DRB CASE ACTION LOG - BLUE SHEET

Project #: 1007488 Application #: 12DRB-7072
Project Name: Sisters of the Order of St. Dominic
Agent: DKKER Pouch Sabatini Phone #:

**Project #1007488 12DRB-70172 Amended Site Development Plan for Building Permit –
Lot(s) D-1E-1, Sisters of the Order of St. Dominic zoned SU-2/IP-EP**

Re: DRB Re-submittal to address comments from 6/20/2012 hearing
Request for Amended Site Development Plan for Building Permit
Project # 1007488; 12DRB-70172

SHEET NO: L-103

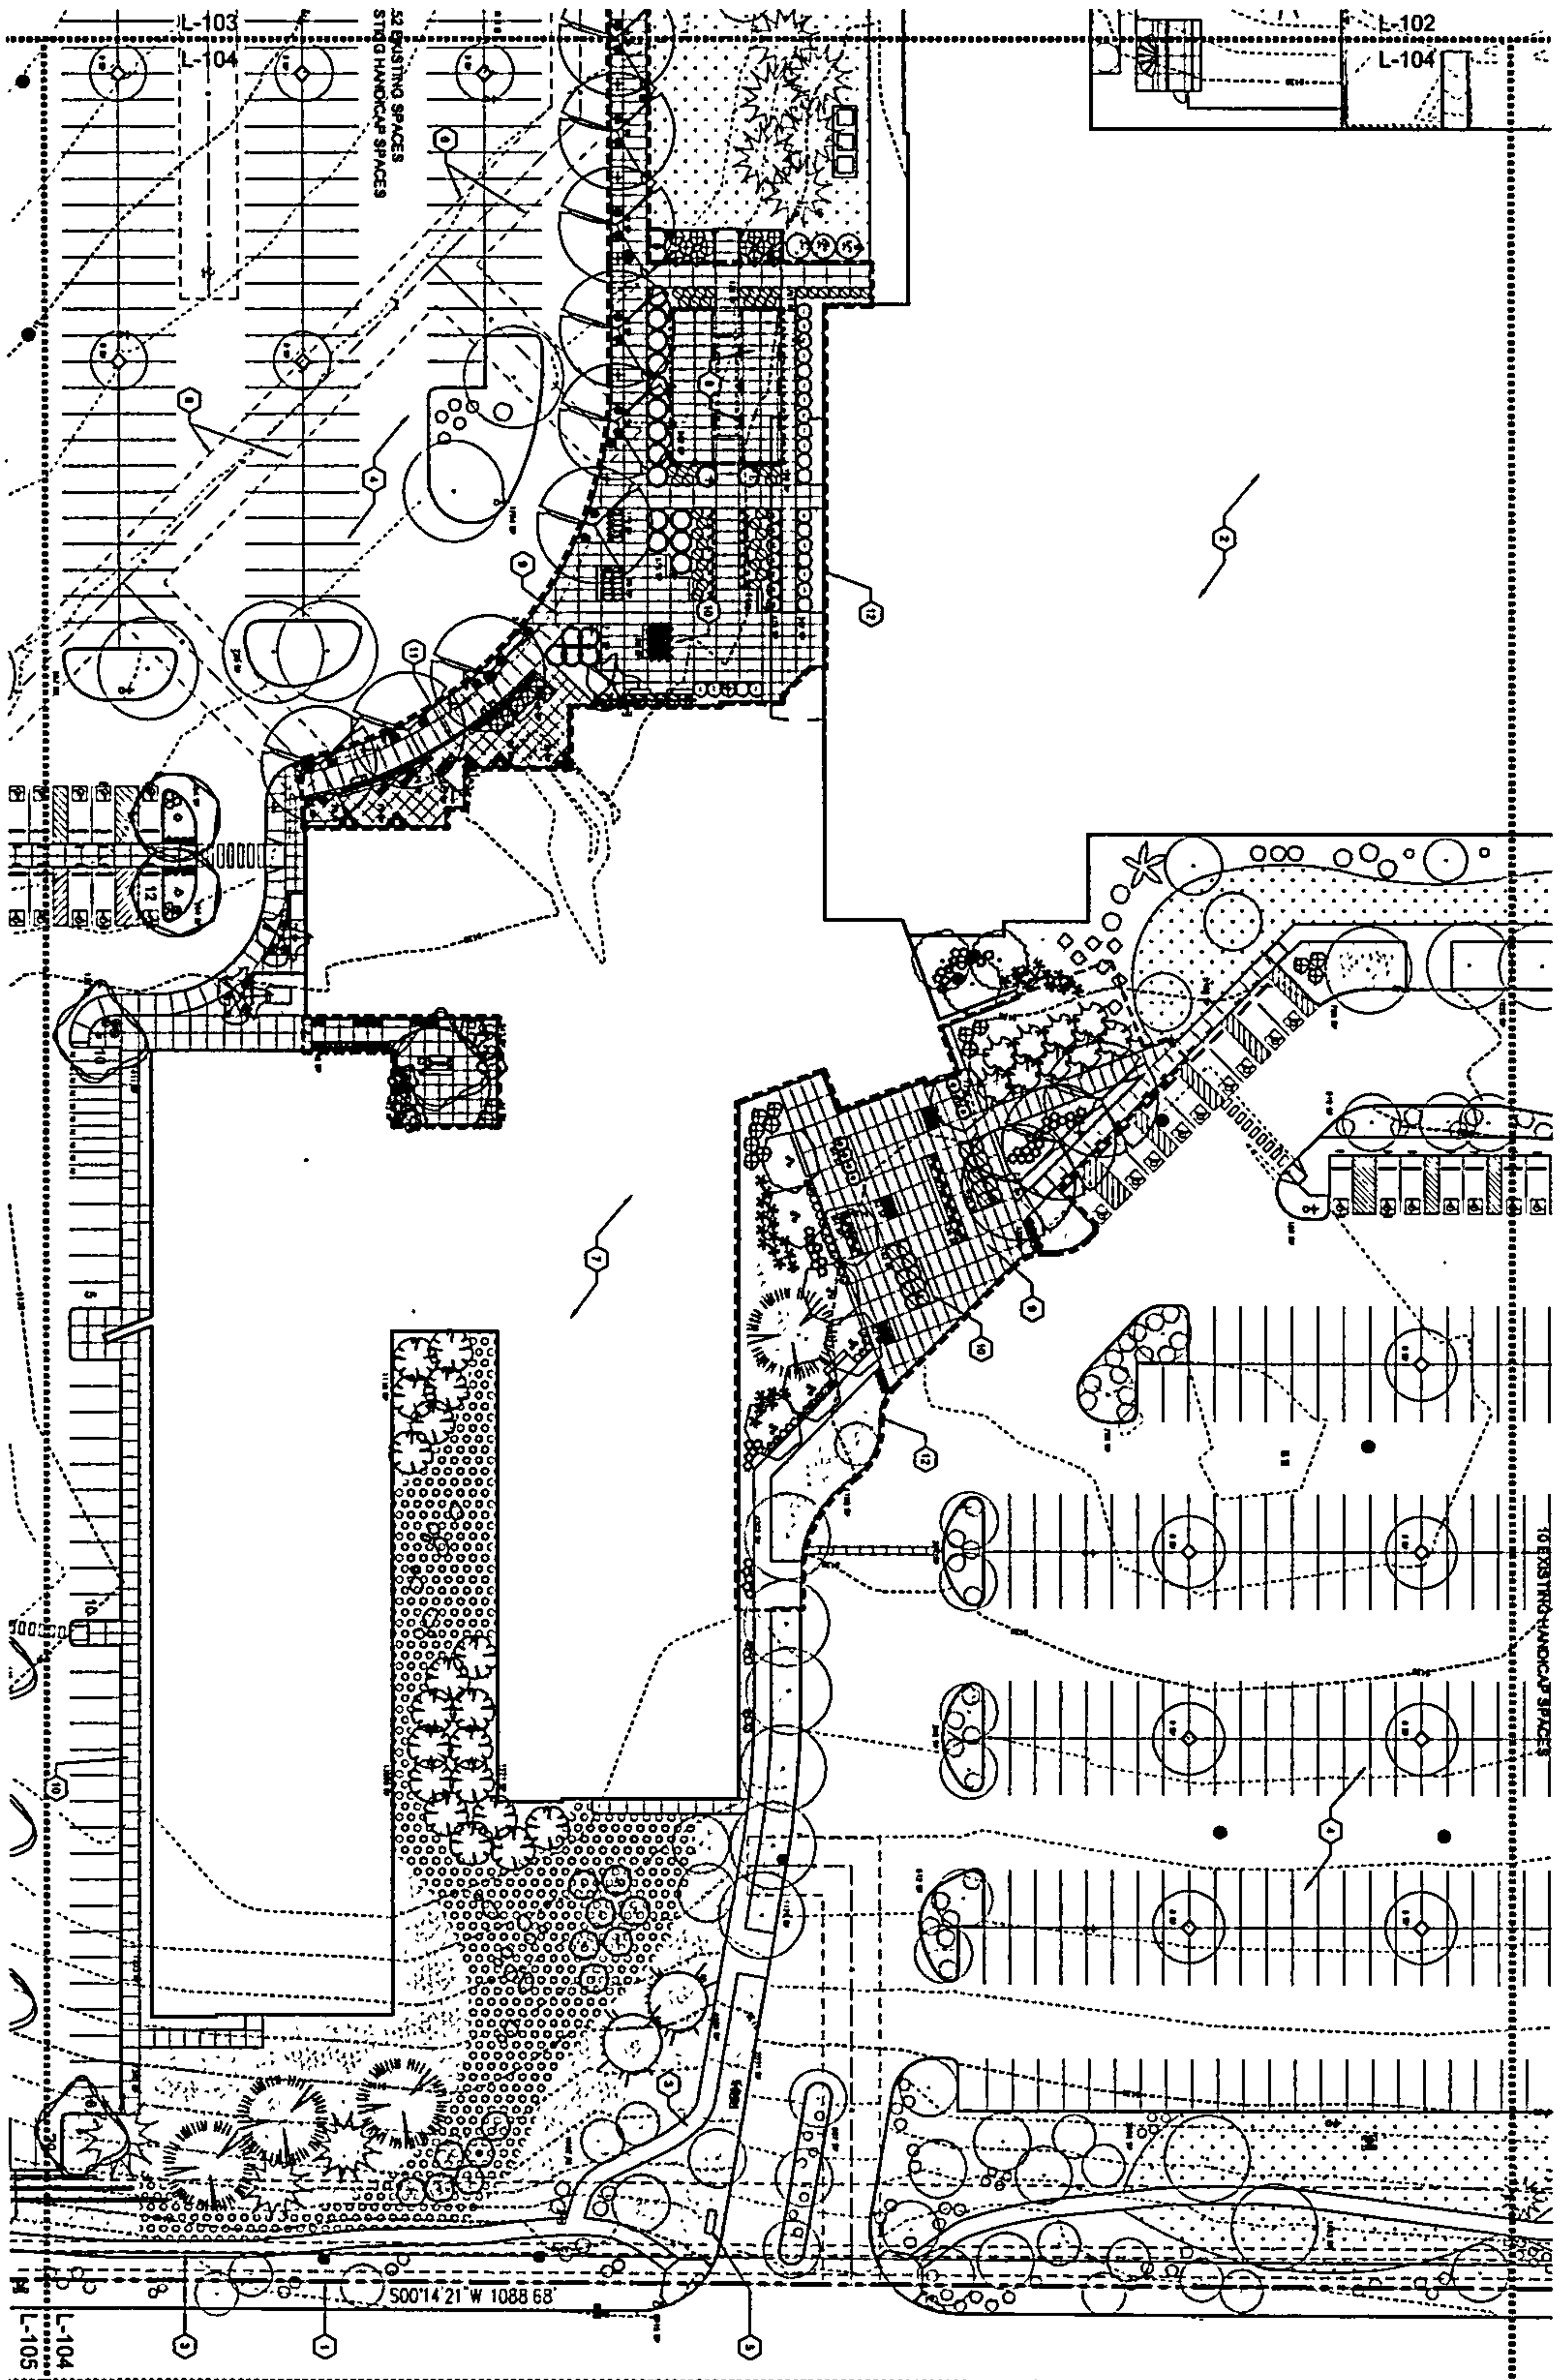
The Landscape Plan needs to provide more specificity in the legend. Parking Lot 'border' areas (that define the parking lot) are not appropriate to count as Usable Open Space.

- h. Seventh Comment: The legends on the Landscape Plans have been revised to locate the symbols adjacent to the plant names.
- i. Eighth Comment: ADA pathways have been more clearly identified as requested.

- g. Sixth Comment: The landscape drawings have been revised to exclude the parking lot 'border' areas from the open space calculation, as requested.
 - h. Seventh Comment: Zoning Enforcement has been contacted and we are awaiting their reply. As of the writing of this letter we have not received their response, but will provide it prior to the scheduled hearing date of 7/25/2012.
